RULE NO.: R161-22.02

NOTICE OF PROPOSED RULE

R161-22.02 : Proposed revisions to the Standards Manual

CITY OF AUSTIN DEPARTMENT OF PUBLIC WORKS	FOUNDATION DETAILS FOR BASE MOUNTED CONTROLLER CABINET	
<i>Sean Bailey, P.E. 9/17/01</i> ADOPTED	THE ARCHITECT/ENGINEER ASSUMES RESPONSIBILITY FOR APPROPRIATE USE OF THIS STANDARD.	STANDARD NO. 830S-1 1 OF 2

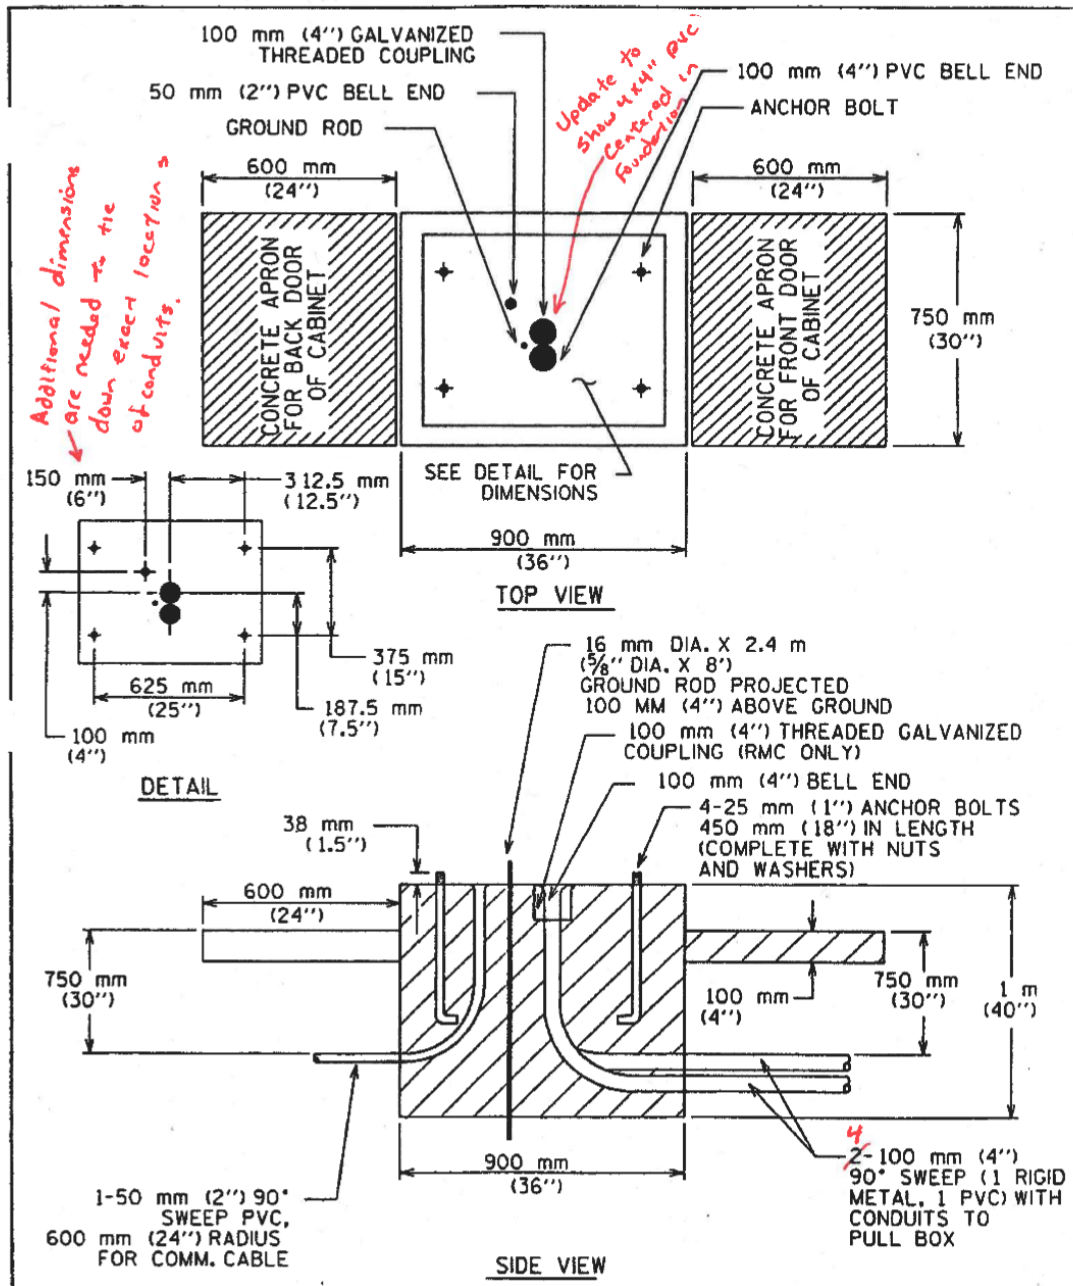
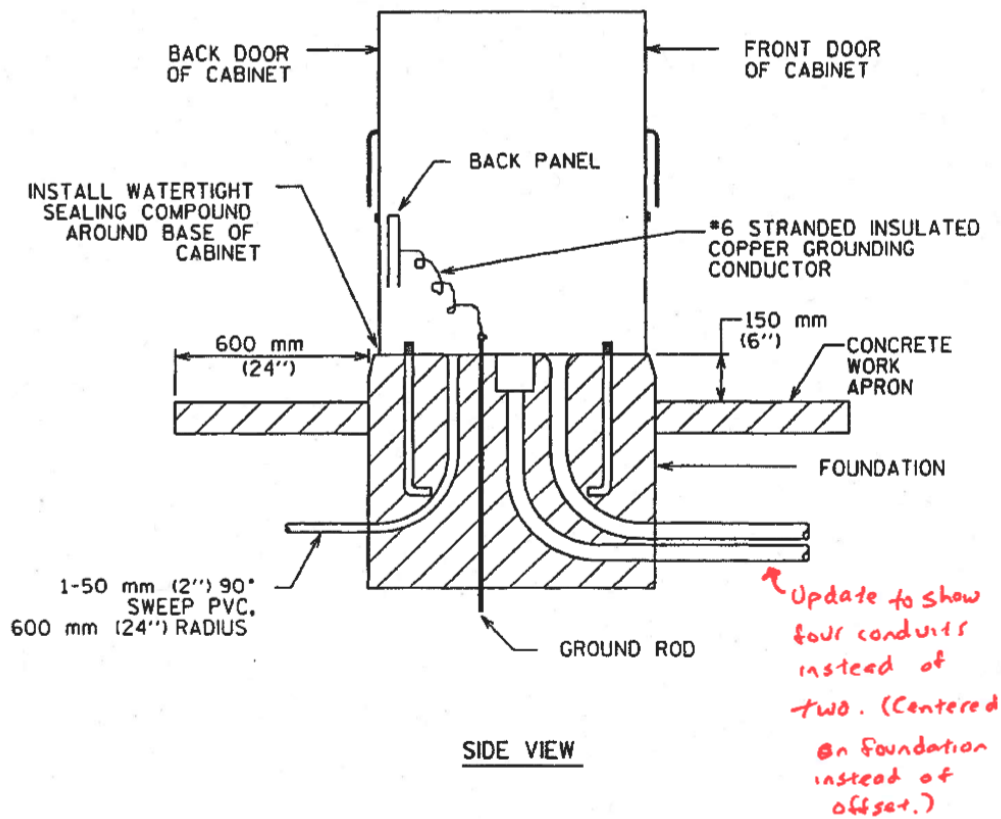
- Standard No. 830S-1, Foundation Details for Base Mounted Controller Cabinet. Standard No. 830S-1, Sheets 1 of 2 and 2 of 2 have been revised to show four each of 4 inch PVC Conduits in the Controller Cabinet Foundation to be used for traffic signal wiring. Additional details and dimensions are provided to reduce confusion on how these foundations are to be constructed. This update is necessary to reflect current practices on traffic signals operated and maintained by the City of Austin.
